## WHYTES GULLY RESOURCE RECOVERY PARK

# Whytes Gully Resource Recovery Park S75w Report

## S75W - WHYTES GULLY RESOURCE RECOVERY PARK HOURS

## RESPONSE TO SUBMISSIONS/PREFERRED PROJECT REPORT - WHYTES GULLY NEW LANDFILL CELL

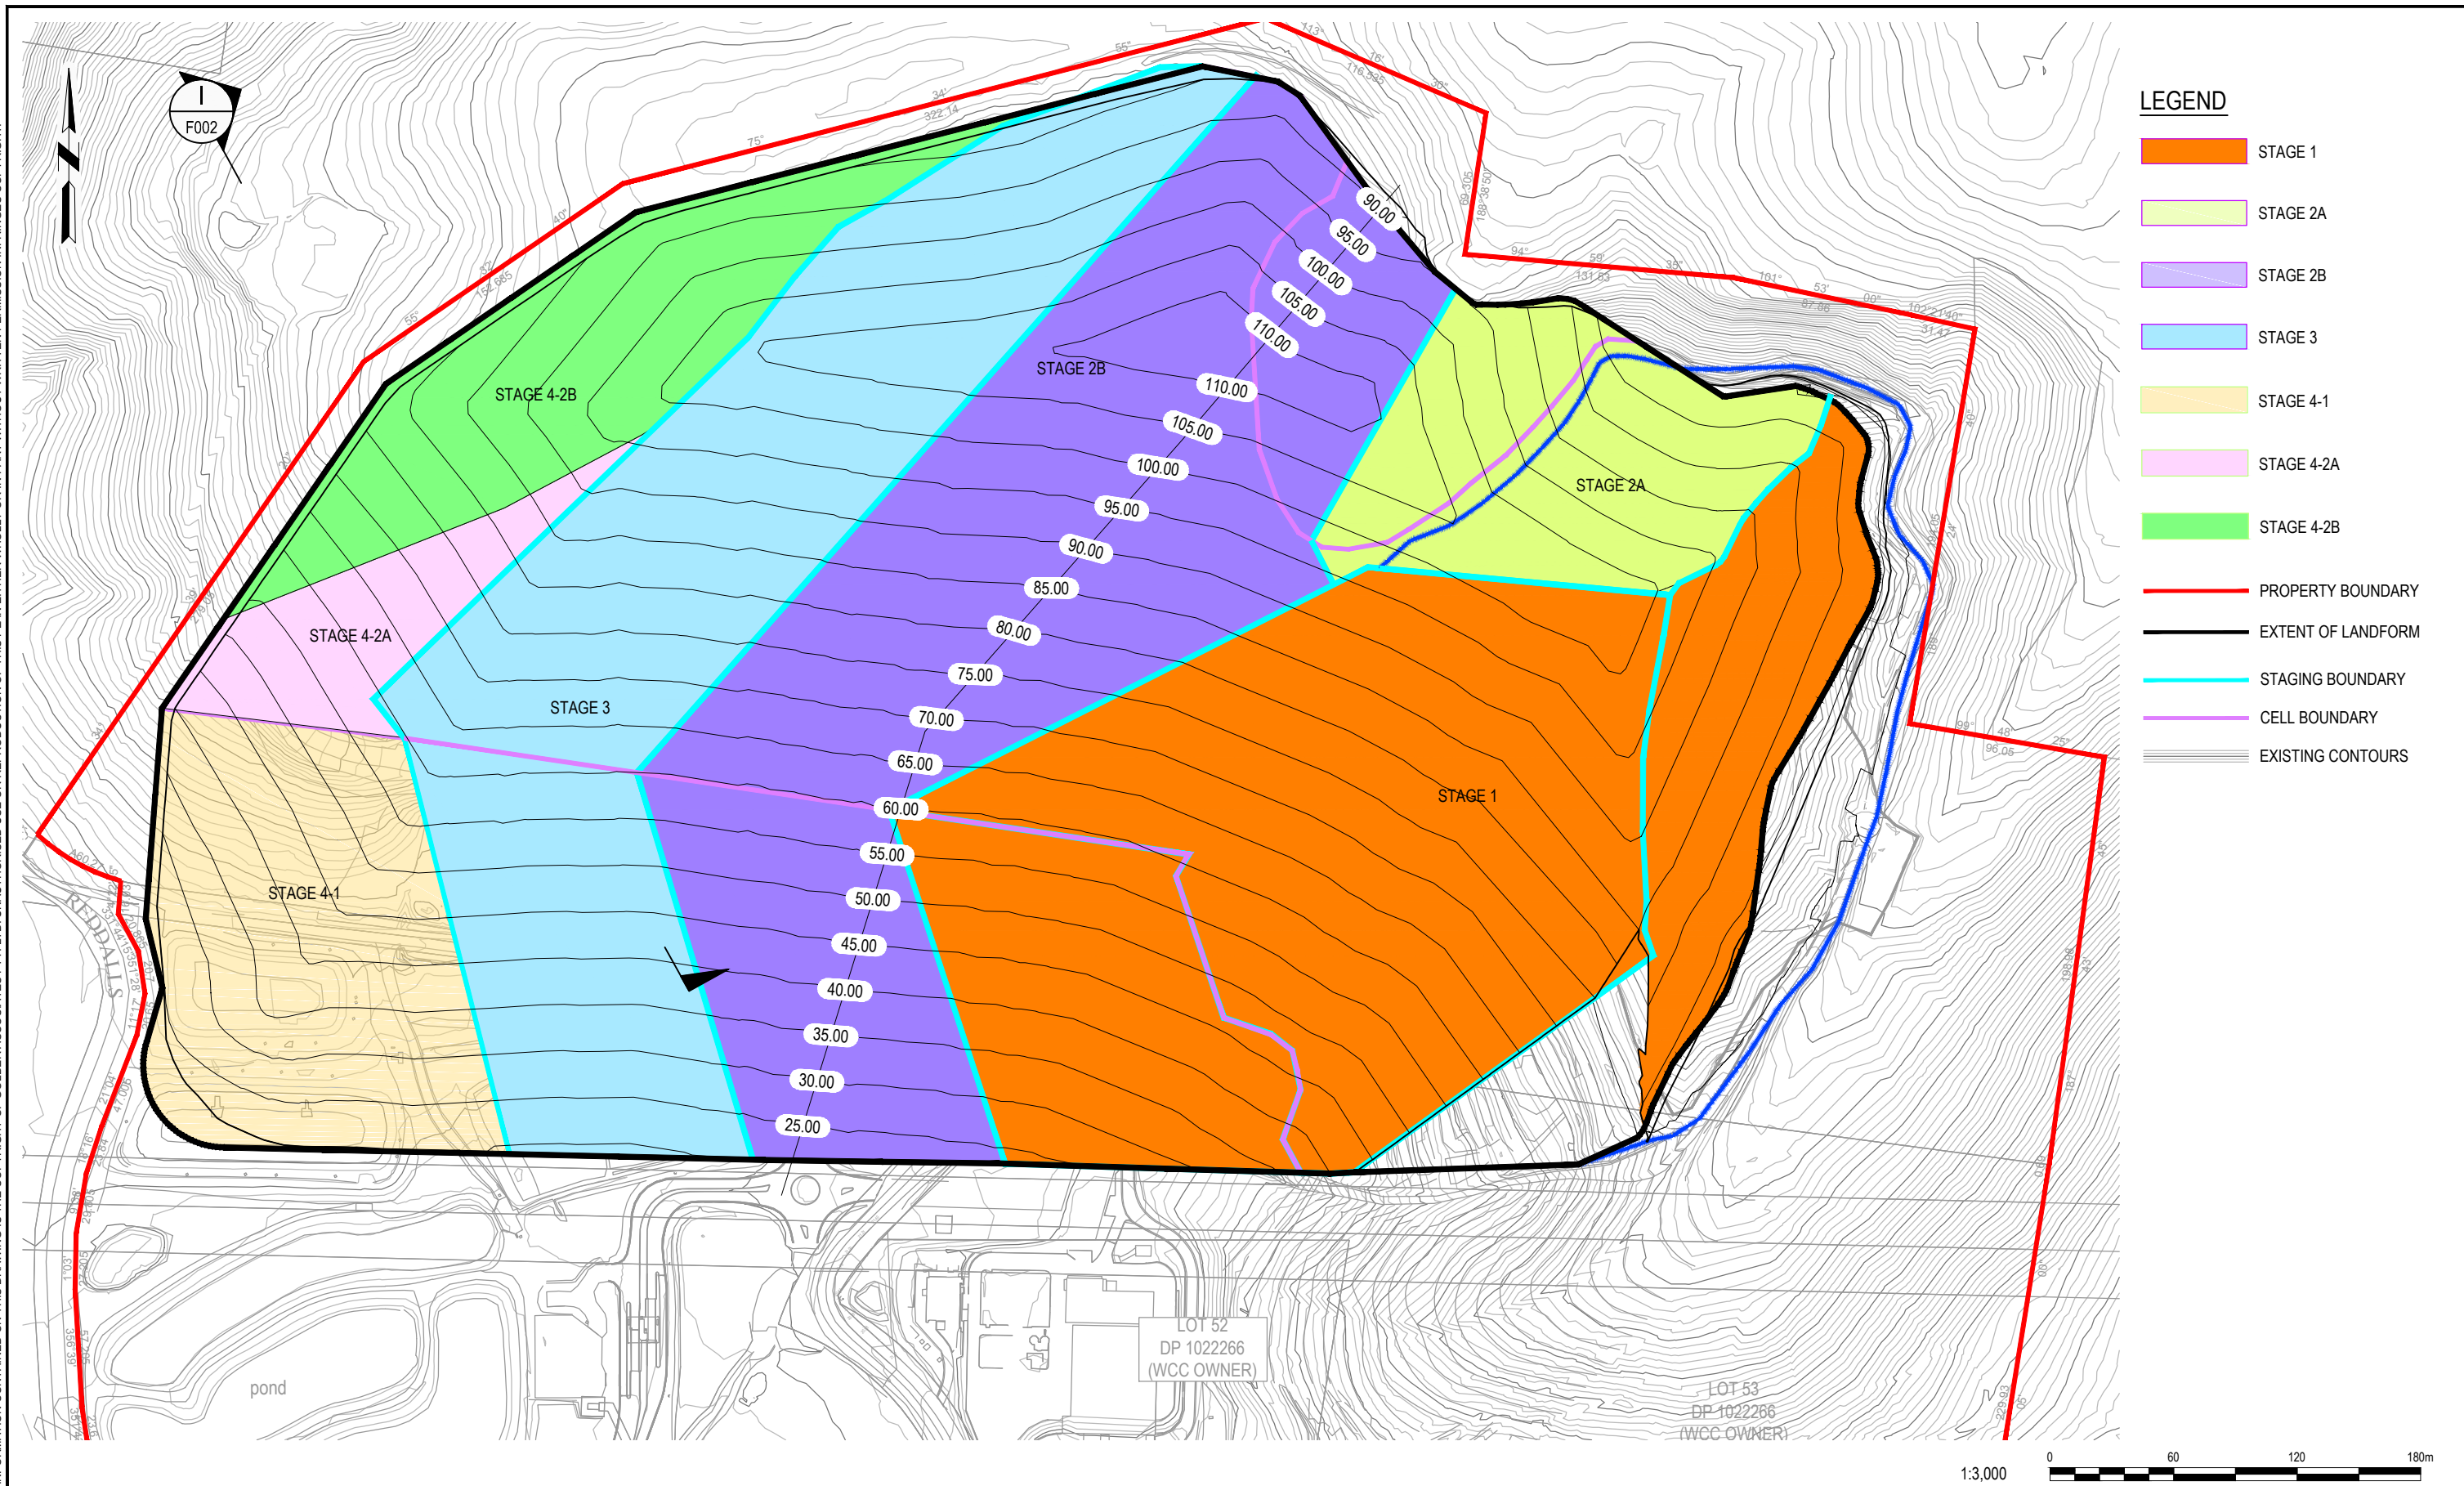
- 1) *The Department needs to be satisfied that the project would achieve an acceptable acoustic environment for local residents.*
- 2) *As discussed at our on-site meeting on 21/9/2012, the Department suggests that you consult with the EPA and consider reducing the footprint of landfilled waste in Stage 4 to increase the buffer distance between N1 and reduce noise levels to comply with the INP amenity criteria. In this regard, a preferred project report which addresses this issue should be submitted to the Department as part of your response to submissions report.*

- 3) *The cumulative (ie construction and operation) predicted noise levels at receivers N1 and N2 are significantly greater than the Project Specific Noise Level (PSNL) – up to 54 dBA at N1 and 45 dBA at N2. The proponent has not provided any description of feasible and reasonable mitigation measures to reduce the predicted levels. The EPA advises that it does not normally Licence to levels significantly greater than the PSNLs.-*
- 4) *The EPA has not included receivers N1 and N2 in the noise limits table in the attached recommended licence conditions, on the assumption that Planning will advise the proponent that the negotiated agreements process in Chapter 8 of the INP is available to them, and that Planning will require the proponent to provide evidence of negotiated agreements being in place with N1 and N2 before any Project Approval can be issued.*

In response to comments 1, 2 and 3, to further reduce the potential cumulative effects of the construction and operational activities at Receiver N1, the final Stage (4-2) of the Project has been broken into two parts (Stage 4-2A and Stage 4-2B) (refer Figure 1). Stage 4-2B would be the final stage of the Project to be constructed. The division of the stages as shown in Figure 1 is such that all activity up to and including Stage 4-2A occurs behind the existing north-east ridgeline, and at a greater distance from Receiver N1 than for Stage 4-2B (refer Figures 2). It is proposed that approval of Stage 4-2B would be conditional on further noise modelling and assessment of mitigation measures to be conducted prior to construction. This has been reflected in the revised draft Statement of Commitments in Section 5.0 of the Report. Further details of the revised staging including proposed volumes and timelines are provided in Section 4.0 of the Report.

In order to address comments received from DPI principally relating to potential offsite noise impacts (refer Section 3.4 of the Report), the final Stage of the EA (4-2) is proposed to be split into two parts (Stage 4-2A and Stage 4-2B) (Refer Figure 1).

Figure 5: Recommended Buffer Distances along Riparian Corridors

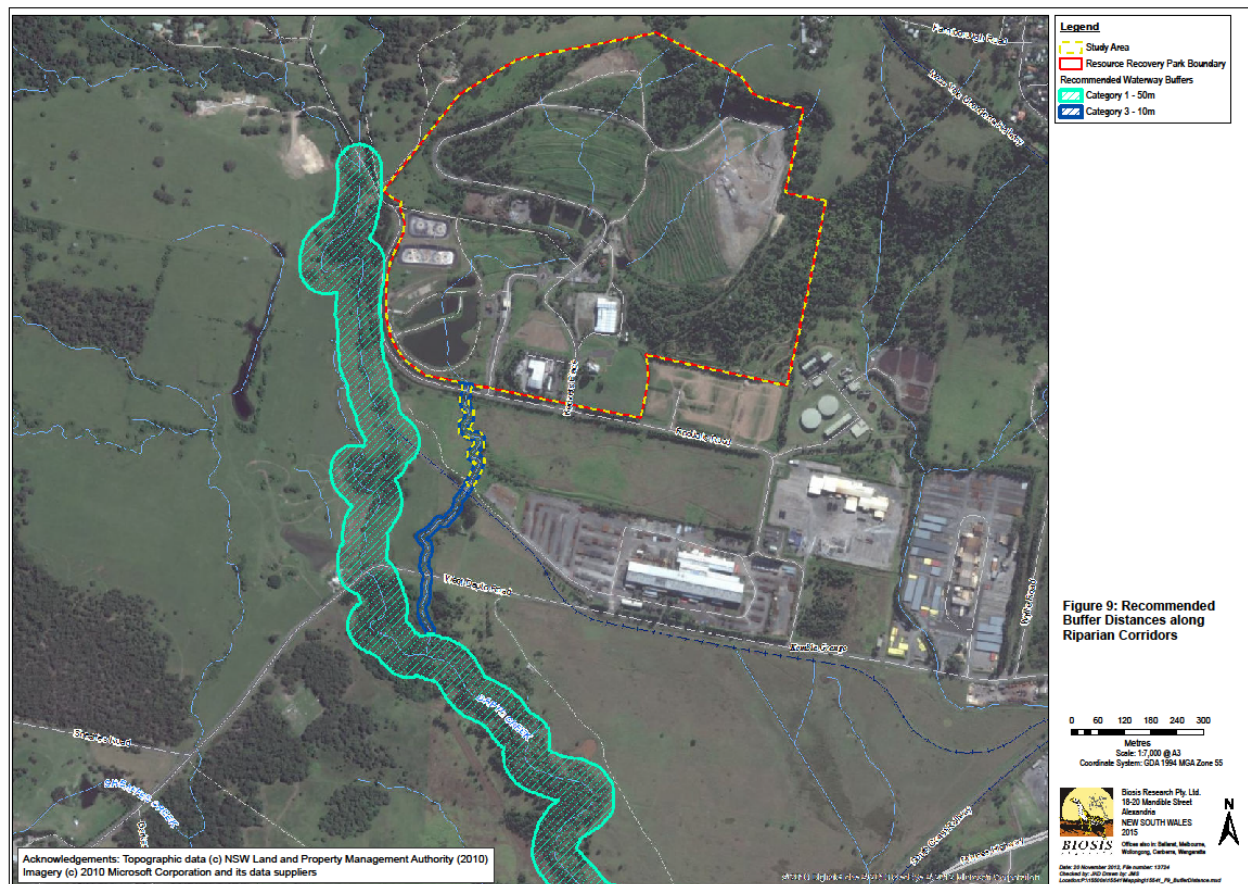
Outcomes from discussions with NOW specifically relating to the Project's potential impact on buffer widths were completed. NOW identified they agree to the usage of buffer widths identified within Map 7 of DIPNR (2004) and a merit based assessment for the historic stream within the resource recovery park boundary as completed in the EA and Appendix F.

Figure 9 of the Biosis report has been amended to further define the buffer widths of the merit based assessment, as well as the usage of Map 7 of the DIPNR (2004) Riparian Corridor Management Study (refer Figure 5 below). All proposed buffer zones are outside of the Resource Recovery Park boundary.

Figure 6: Time series of measured and modelled 24-hour average PM<sub>10</sub> concentrations at R1 (Stage 4).

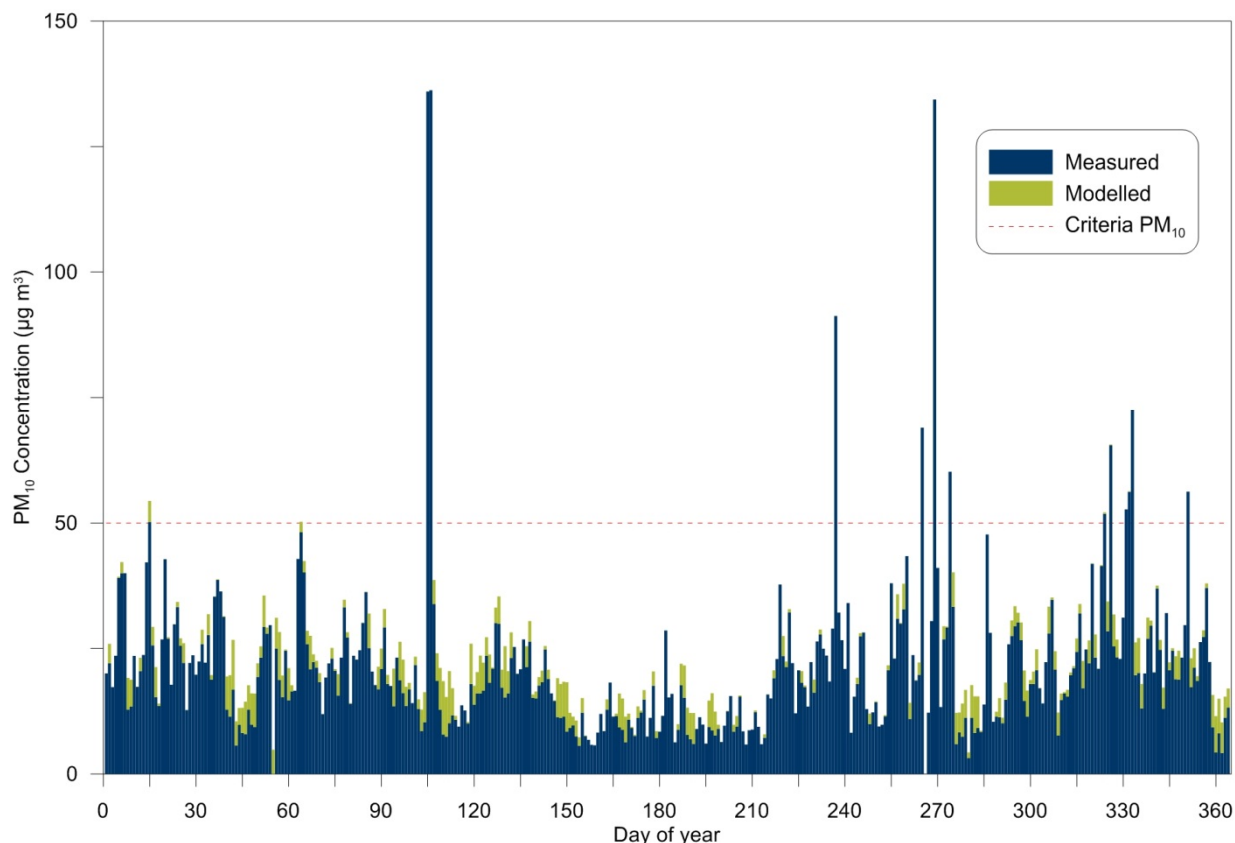
- 1) *The issue of PM10 24-hour average exceedances requires some clarification. The proponent should confirm the cumulative 24-hour average PM10 assessment results. If the results shown in Figure 7.12 are correct, the proponent should provide a revised assessment including additional controls to ensure no exceedances are predicted to occur due to project operations. If the assessment does not predict exceedances of impact assessment criteria for PM10, the EPA recommends conditions of approval.*

The NSW EPA was correct that the text and Figure 7.12 were conflicting. Figure 7.12 was correct and did show one additional cumulative exceedance of the 24-hour average PM10 criterion at R1 during Stage 4. It is noted however, that this was a conservative assessment and the exceedance was less than  $2 \mu\text{g}/\text{m}^3$  above the criterion, on a single occasion.

Figure 6 shows the updated time series (measured and modelled incremental increase) for the nearest residence (R1) during Stage 4, assuming that dozer travel routes are kept moist. This results in no predicted additional exceedances above the 24-hour PM<sub>10</sub> criterion.
